**Department of Public Works
City Engineering Division**

Re: Petition No. 1889 — Wayne State University, request permission to construct a pedestrian bridge/walkway over vacated Brush Street south of East Canfield.

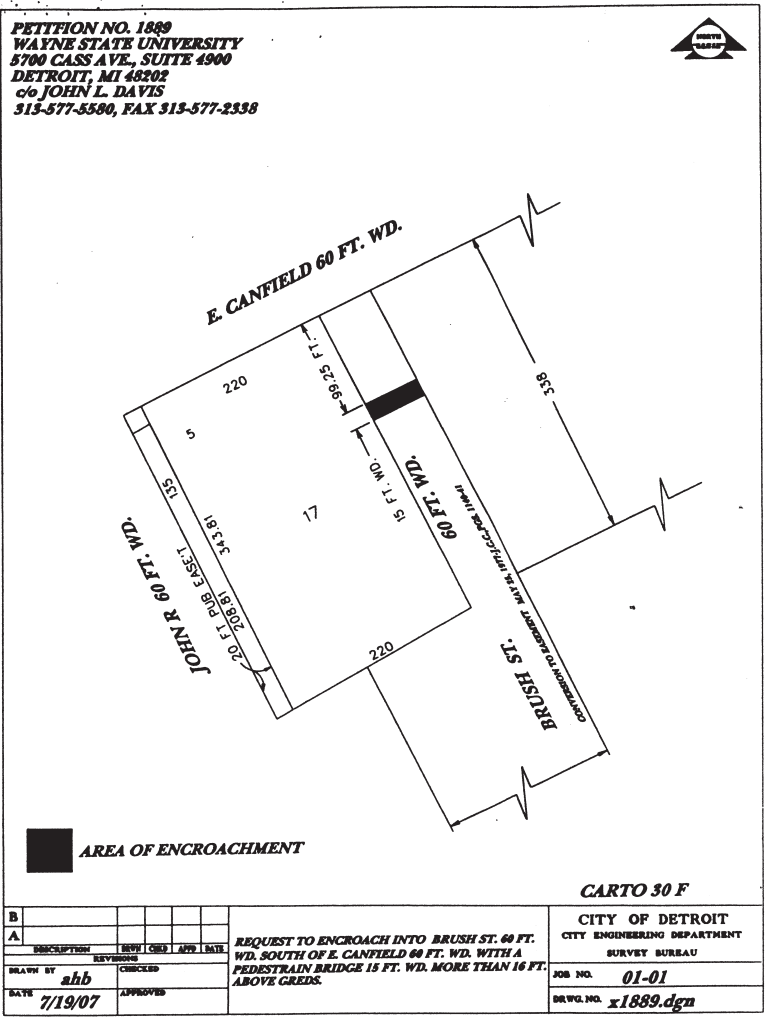
The Public Lighting Department (PLD) reports having underground conduit runs, hand holes, and manholes on Brush Street in the area requested for encroachment. PLD requires 24-hour vehicle access to the construction site to perform circuit and cable maintenance. As per PLD requirements, any structure proposed to be built shall maintain a minimum of three (3) feet horizontal clearance and 12-inch vertical clearance from the PLD conduit bank and manholes. The contractor should take necessary precautions not to damage PLD manholes and conduits banks, which carry high voltage feeders, while doing any excavating or using heavy earth moving equipments.

The Detroit Water and Sewerage Department (DWSD) reports there is existing a 12 feet sewer, 16-inch and 8-inch water main in Brush Street between East Canfield and Willis easement. DWSD has no objections to the proposed encroachment for installation of the pedestrian bridge provided minimum clearances are maintained.

Traffic Engineering Division (TED) reports no objections to the encroachment provided that a minimum under-clearances of 16 feet is maintained from the grade level.

DTE Energy reports no objections to the proposed encroachment provided that the bridge foundation on the west side of

Brush Street be at least a minimum of three (3) feet away from DTE's existing gas facilities (16-inch CI-10# gas main). Also the public easement (vacated Brush Street) where the proposed encroachment for the pedestrian bridge construction must be free from any obstructions for DTE's equipments to do any repairs and/or relocations of DTE's existing gas facilities.

Provided, That the encroachment has a minimum under-clearance of 16 feet from grade level; and further

Provided, That any structure proposed to be built shall maintain a four and half feet (4'1/2") horizontal clearance from the PLD conduit bank and manholes. Also 10 feet horizontal clearance for the overhead PLD lines and installations. The contractor
